ADDENDUM NUMBER 2ISSUED September 9, 2010

**WASHINGTON COUNTY SERVICE AUTHORITY
MIDDLE FORK WTP UPGRADE TO 12 MGD**

Prepared by: Olver - A CHA Company
1116 South Main Street
Blacksburg, VA 24060
Olver Project No.: 12367.13

ELECTRICAL HANDHOLE DETAIL

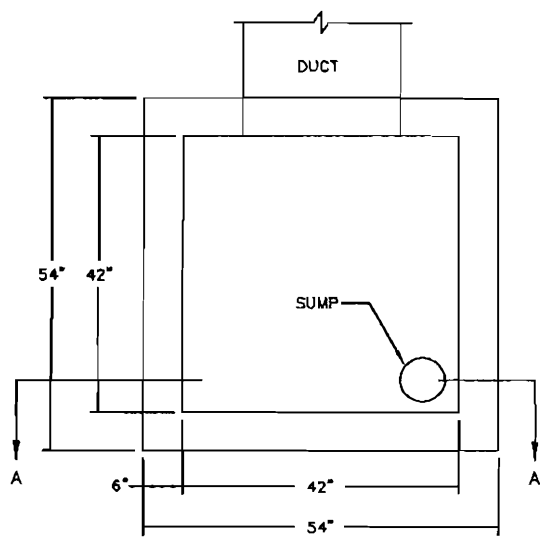
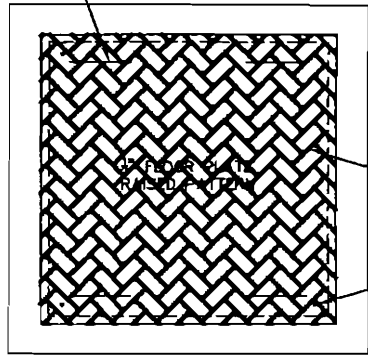
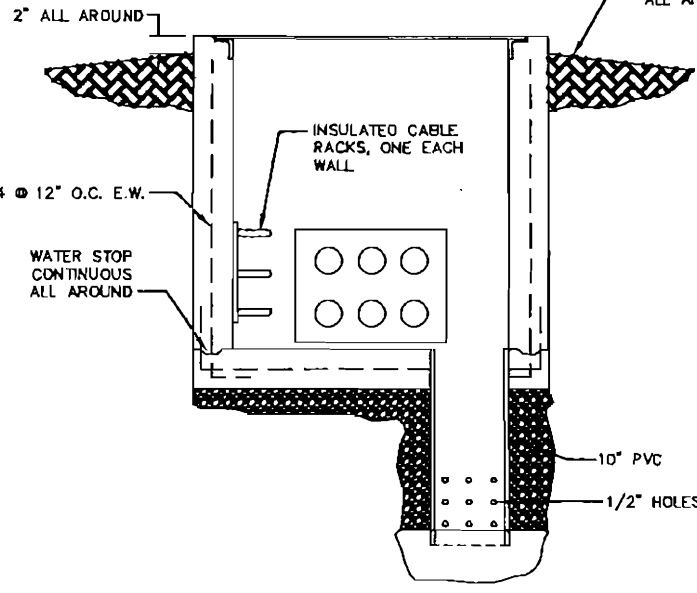
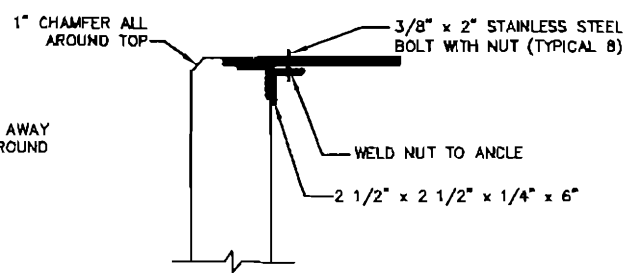
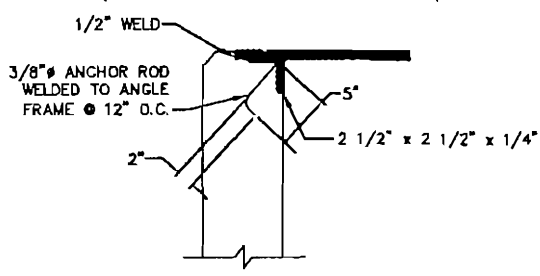
- AD2-68 Sheet E010 - REPLACE panel P2 Schedule with revised Schedule, *attached*.
- AD2-69 Sheet E011 - ADD Fiber Optic Pullbox detail, *attached*.
- AD2-70 Sheet E011 - ADD Electrical handhole detail, *attached*.

DETAIL - EMERGENCY EYEWASH/ SHOWER (M006.6)

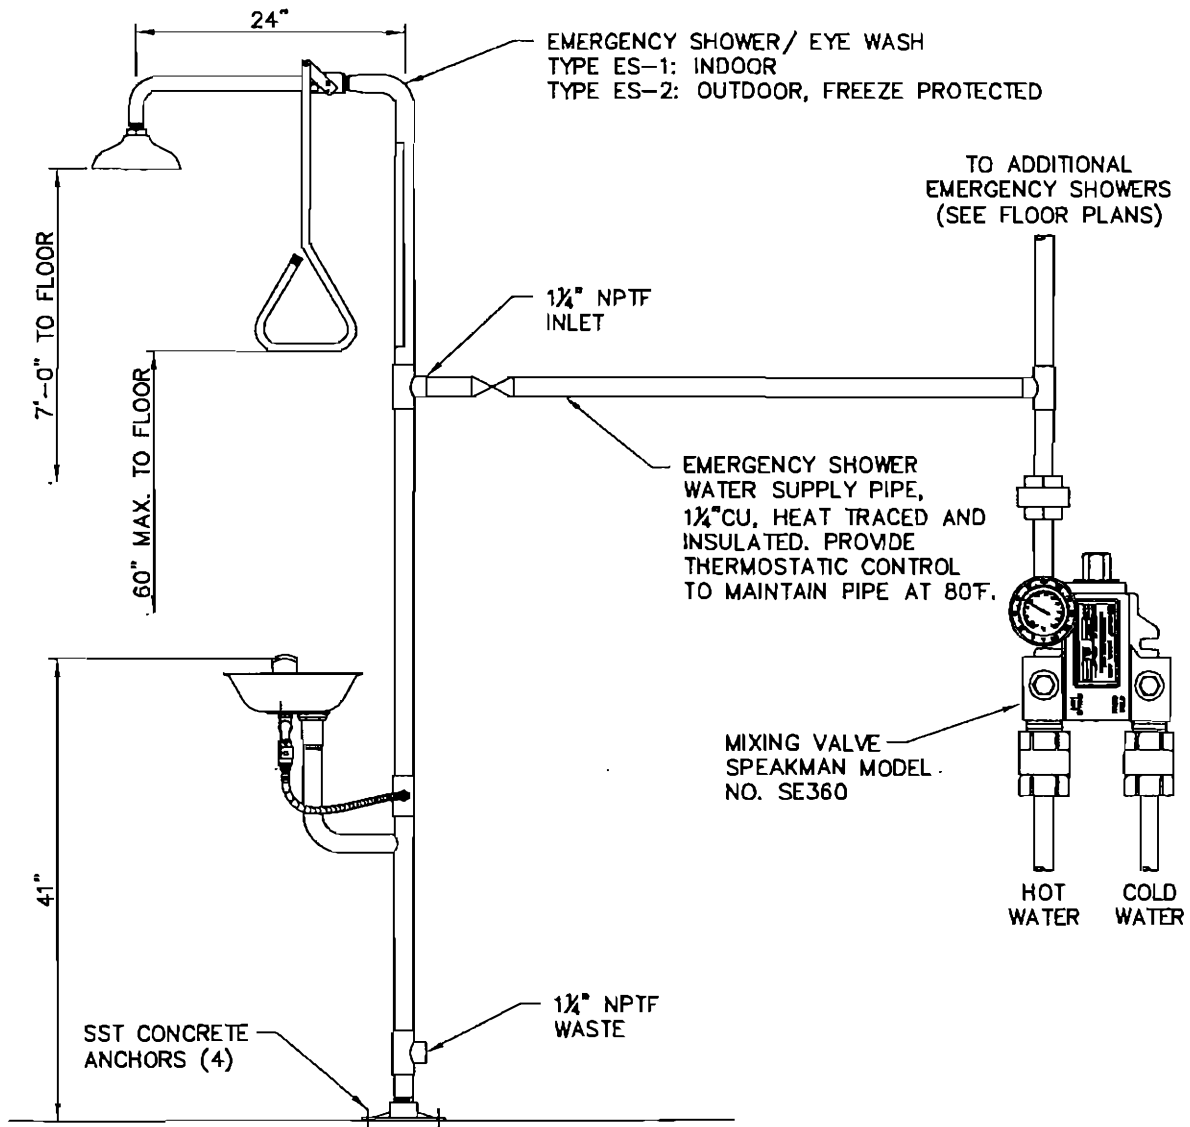
- AD2-116 Sheet M006, ADD Emergency Shower detail, *attached*.
- AD2-117 Sheet M008, REVISE Sheet M008 as *attached*.
- AD2-118 M008 - In the unit heater schedule, CHANGE ratings of Unit heater UH-10, UH-11, UH-12, and UH-13 from 2.5 kW to 7.5 kW.

S506.11
S210
S211

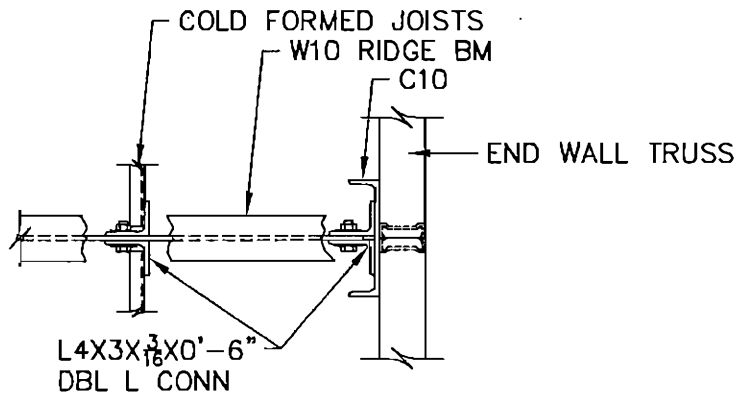
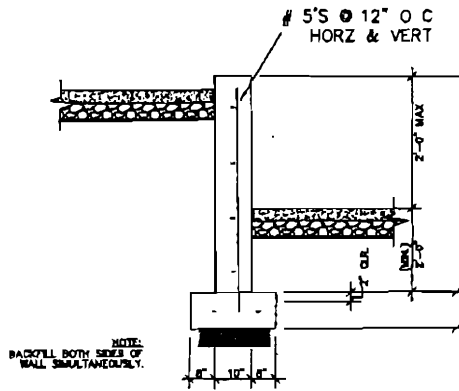
- AD2-170 S506, **ADD** the *attached* sections S506.10/S210, S506.11/S210 & S506.12/S506.
- AD2-171 On plan sheet C101 Delete the note requiring remove and dispose abandoned tanks from the project. These tanks will be removed from the project site by others prior to start of construction.

**ELEVATION DETAIL BOOSTER
PUMP STA SOUTH ENTRANCE**

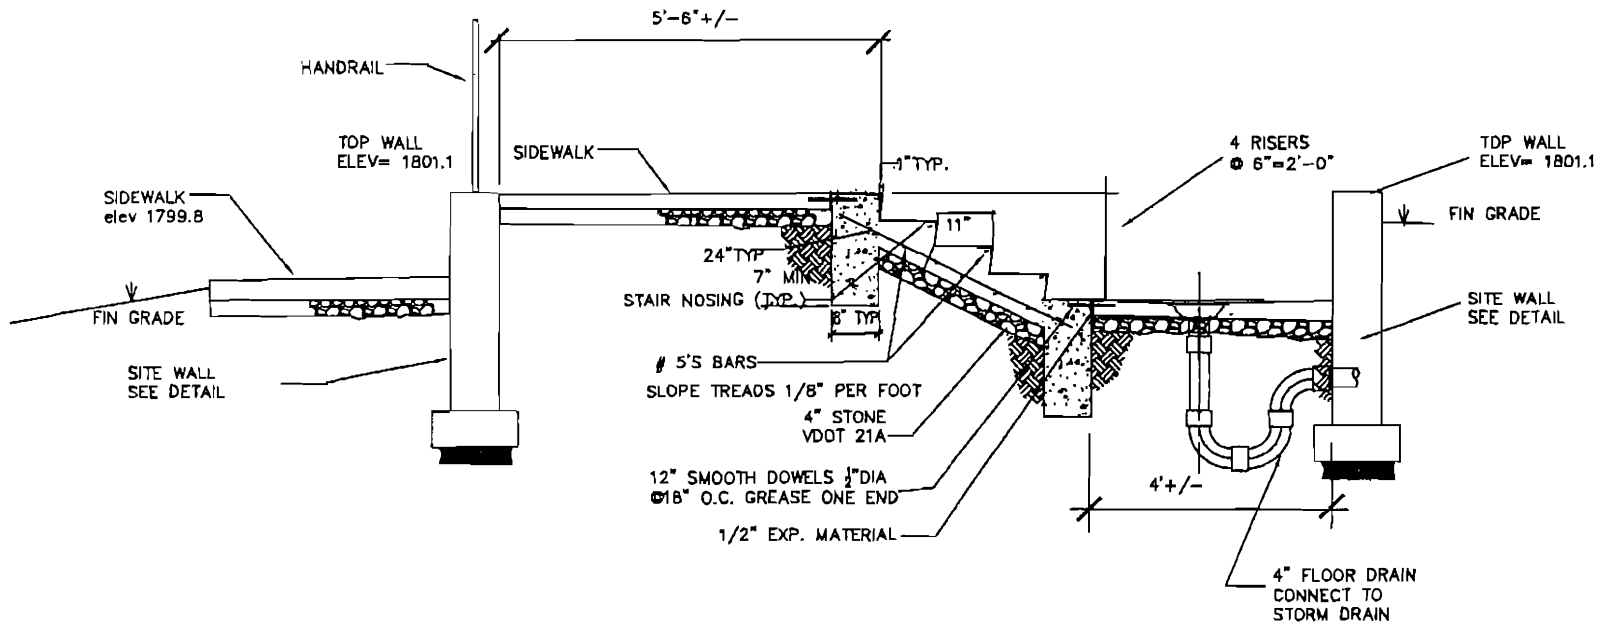
- AD2-176 Plan sheet A144 delete details A and B from the plans.
- AD2-177 Add the attached detail of the Intermediate Booster Pump Station Building South entrance to the plans.

CHANGE TO SHEET A134

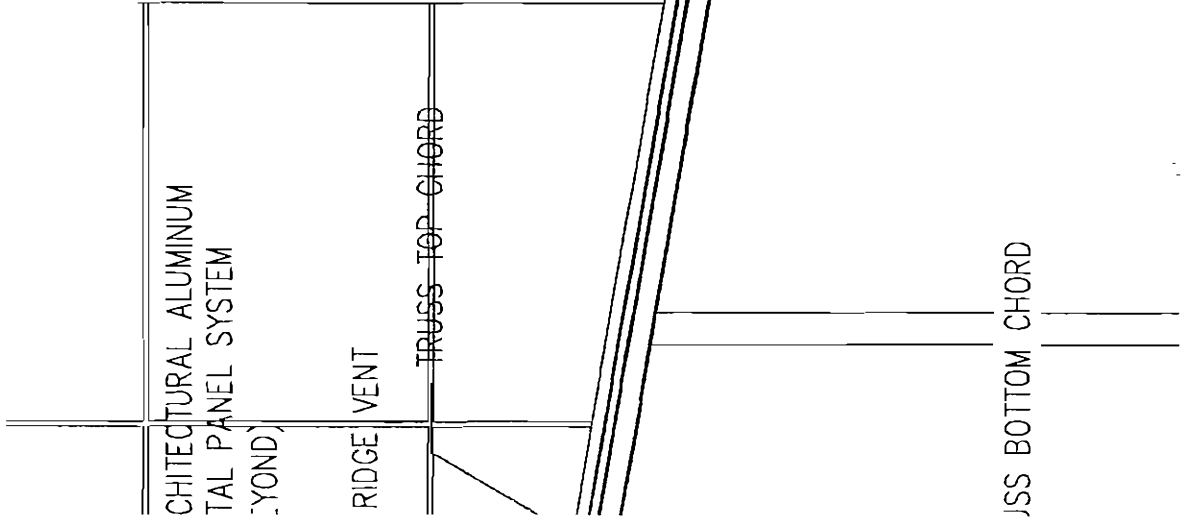
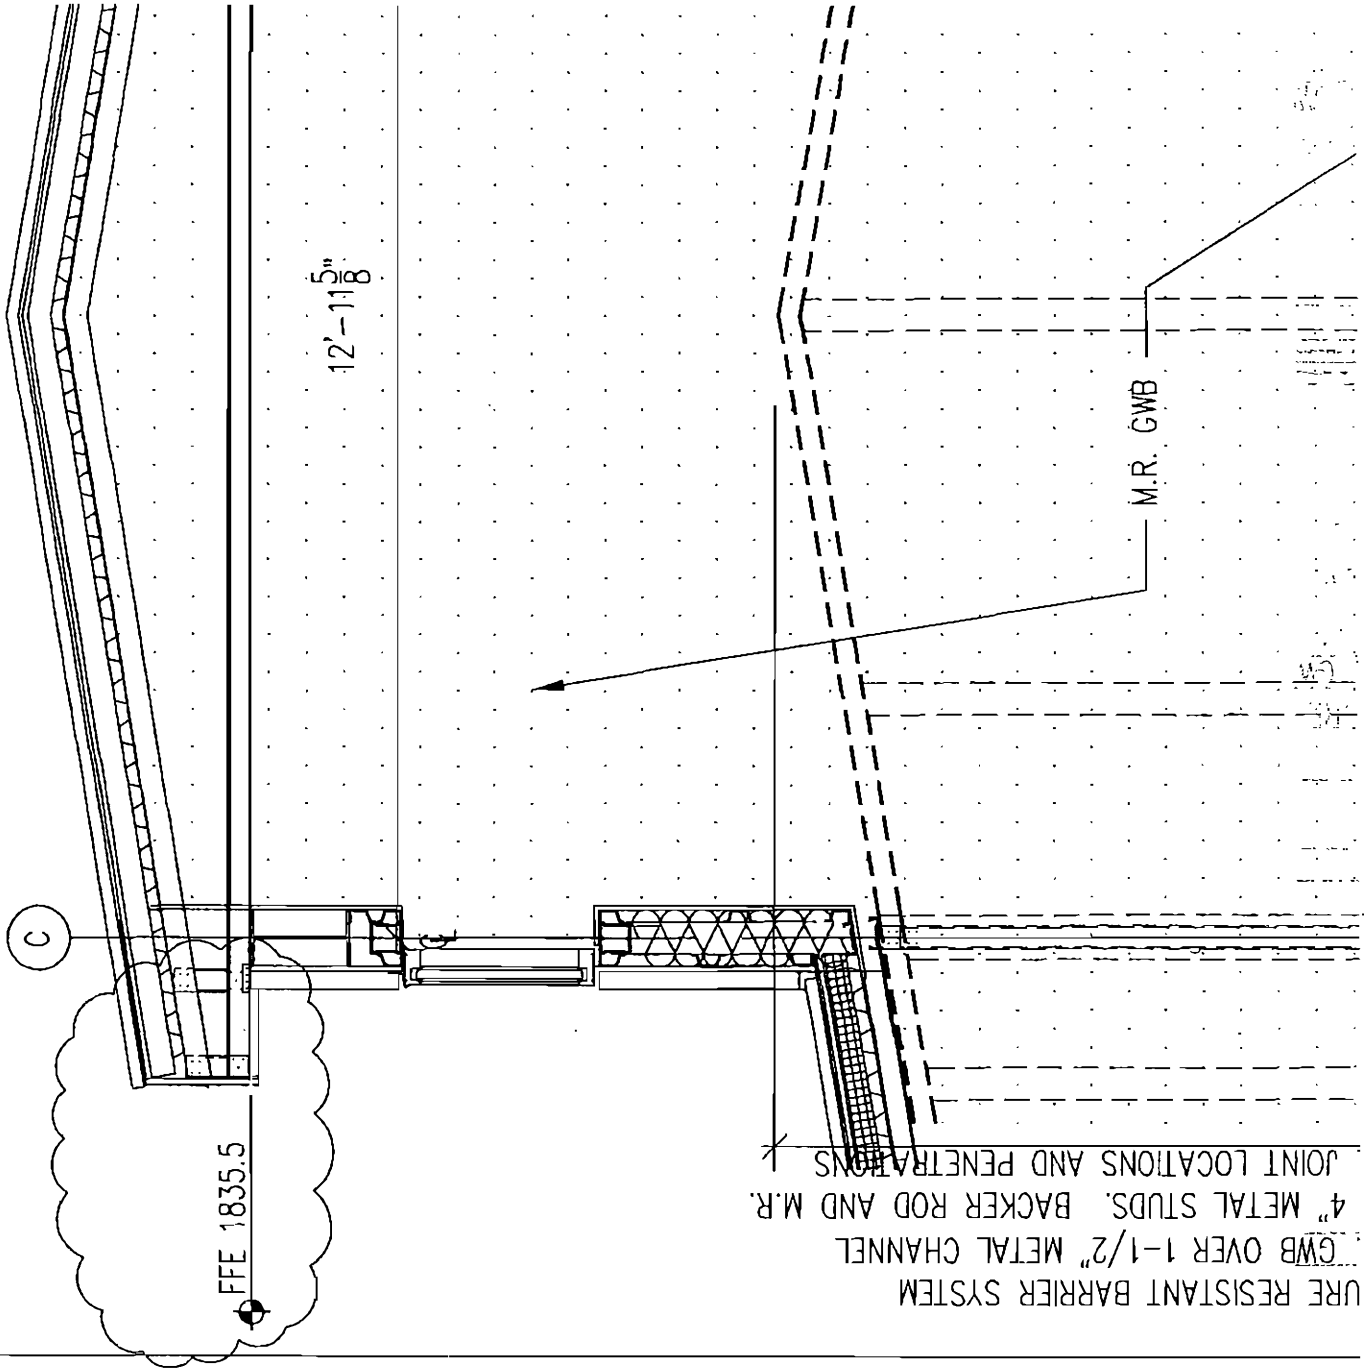
- AD2-179 Modify the following plan sheets per the attached details: A100, A134, A135, A142, A160, A170, A200, A260, A300, A315 and A360.
